CITY OF FRANKLIN
PLAN COMMISSION MEETING*
FRANKLIN CITY HALL COUNCIL CHAMBERS
9229 W. LOOMIS ROAD, FRANKLIN, WISCONSIN
AGENDA
THURSDAY, MAY 20, 2021, 7:00 P.M.

Affidavit of Correction

Affidavit of Correction to The Glen at Park Circle Condominium Addendum No. 4 (Document No. 10921372), for the purpose of relabeling the Unit 9 basement from “unfinished basement” to “finished basement”. Unit 9 is one of the two units located in Building 5. The finished basement would have an entertainment room, sitting room, game room with window well, bathroom and unfinished laundry. Separate building permits are required for this basement alteration.

AFFIDAVIT OF CORRECTION

FOUNDATION PLAN
NOT TO SCALE

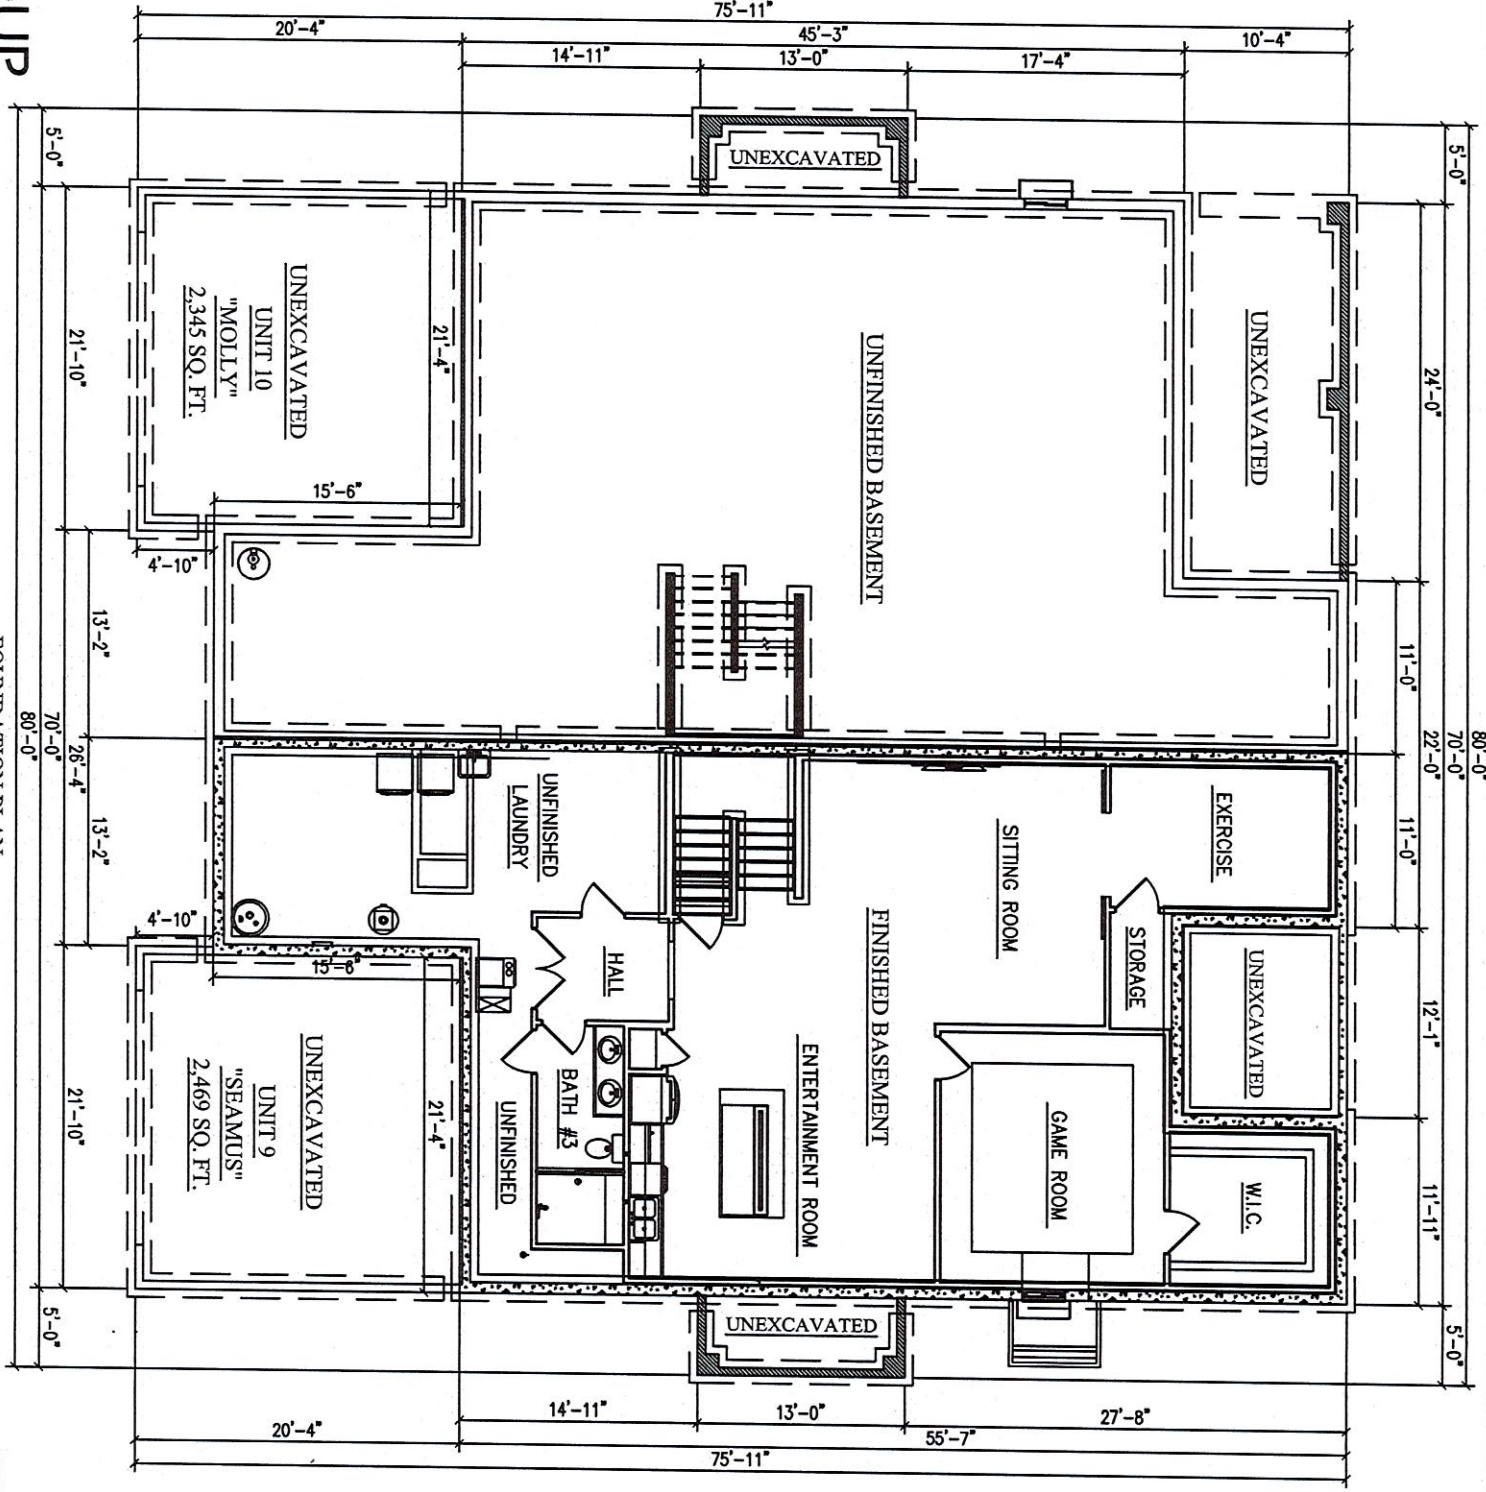
It is worth noting that the “game room” depicted in the correction instrument (sheet 2 of 5) should be considered a bedroom per Unified Development Ordinance (UDO) definition below:

Unit No. 9 currently has two (2) bedrooms, and it would have three (3) bedrooms if this correction is approved. The District Standards table for the R-8 zoning district require additional floor area for each bedroom in excess of three (3), so this requirement is not applicable to this project.

No additional parking is required for the third room because the minimum parking for two-family dwelling structures is 2 spaces per D.U. (dwelling unit), regardless of the quantity of bedrooms.

The foundation plan for Unit 9 as graphically shown on Sheet 2 of 5 of aforesaid document, incorrectly states the basement area as "UNFINISHED BASEMENT".

The basement area shall be labeled "FINISHED BASEMENT" and shall be graphically shown per the attached sheet.
